Responses to:

Plans correction report 000067-2021-APP

Dated: 9/12/2021

Sweet Acacia, LLC.

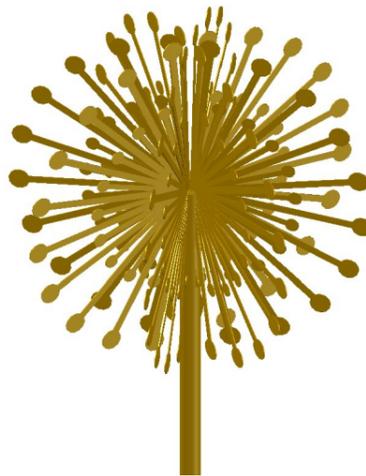
b. Inclusions of plazas, arcades, promenades, greenways, water features, and/or public art.

c. Inclusion of paseos or other acceptable permanent weather protection for pedestrians.

d. Application of design materials such as special paving, site furniture, specialty light fixtures, approved signage, and "LEED" design features.

Inclusion of structured parking that provides 76% of required parking spaces.

Inclusion of public art. See below proposed sculpture to be 8' in diameter located as shown in plans.

Inclusion of porte-cochere providing permanent weather protection for pedestrians.

Application of special paving, specialty light fixtures, approved signage.

Addition of electric vehicle stations.

Inclusion of trash facilities inside the building envelope.

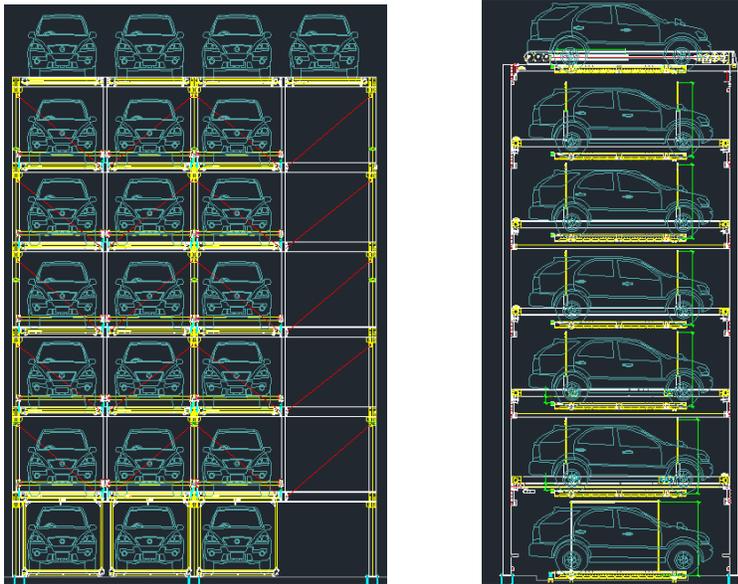
e. Please provide a color rendering.
